**PLANNED UNIT DEVELOPMENT
& SUBDIVISION STAFF REPORT****Date: July 24, 2008****DEVELOPMENT NAME**

Grandview Apartments

Grandview Apartments Subdivision

Planned Unit Development Approval to allow multiple buildings on a single building site with shared access and parking, and Subdivision Approval to create 2 lots.

SITE PLAN

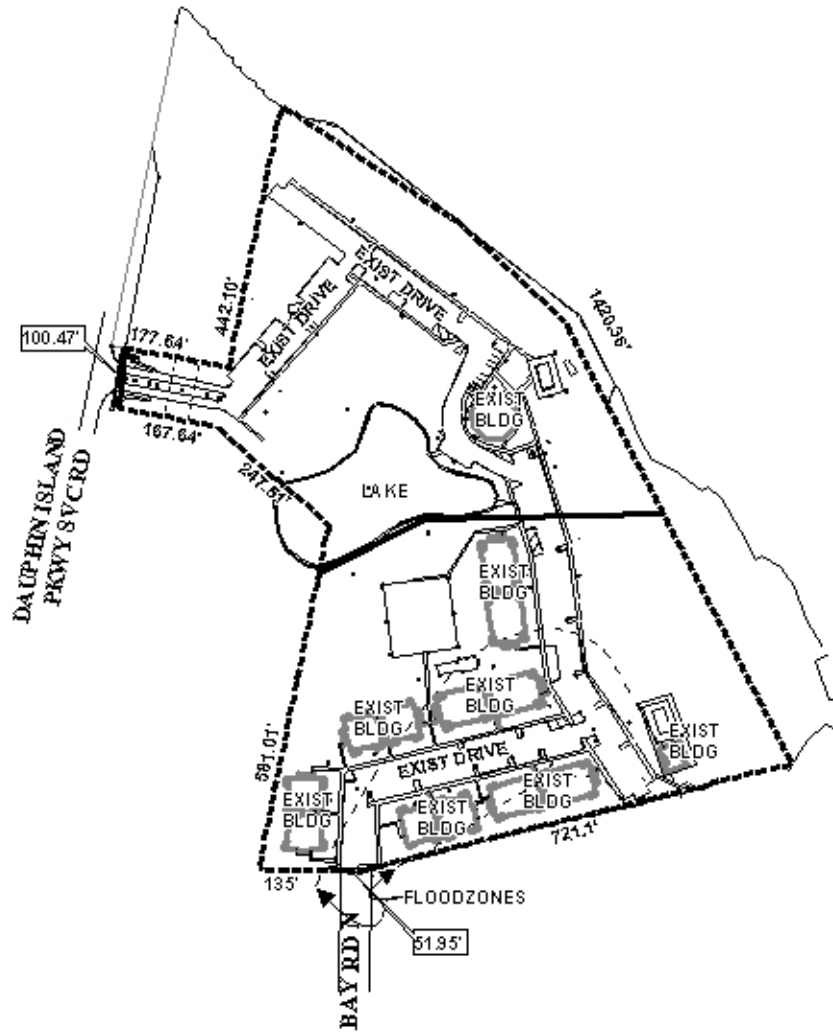
The subdivision portion of this request was heldover from the June 19 meeting to allow the applicant an opportunity to submit the accompanying PUD and to revise the plan to illustrate access to Marina Drive South for both lots (instead of Lot 2 accessing Bay Road, a substandard minor residential street). Access to the site since development has been via Marina Drive South.

The applicant has submitted the PUD; however, the plan was not revised to eliminate the access to Bay Road. In lieu of that revision, the applicant has provided a statement indicating an intent to build Bay Road to County standards, if approved. Construction of Bay Road would improve the situation, however there is still concern of having the sole access to a multi-family development such as this via a minor residential street. While the plan indicates a driveway to Bay Road N, it appears that the gravel from Bay Road N is not a formal driveway, but simply extends gravel within the site to the existing parking lot. In fact, this access to Bay Road appears to be recent in that it did not exist in 2002. City of Mobile aerials from that year clearly illustrate a dumpster where this “drive” is now located. Further, while not as clear, the 1997 aerials appear to show the same dumpster location.

Given the concerns raised about access to proposed Lot 2, under normal circumstances the applications would be recommended for holdover to allow the submission of a Traffic Impact Study OR revision of the plan to illustrate that access be limited to Marina Drive South. However, as the subdivision has already been heldover, it must be acted upon unless the applicant requests another holdover. Further, as stated previously, one of the reasons for the original holdover was to revise the plat to eliminate access to Bay Road North – eliminating the generation of additional traffic along a minor residential street.

The applicant's engineer met with staff during the holdover period and some discussion was held regarding the potential of construction of Bay Road North. While no determination was made during that meeting, further review does not find that such access would be beneficial or appropriate for those neighboring properties along Bay Road North.

1. substandard access (Bay Road N) to the site is not appropriate for the development;
2. the subdivision does not promote orderly development based on access via a minor residential street;
3. approval of the subdivision would create a violation of the Zoning Ordinance if the accompanying PUD is not approved.

1. access as provided generates excess traffic along minor residential streets in residential districts outside the PUD
2. substandard access (Bay Road N) to the site is not appropriate for the development;
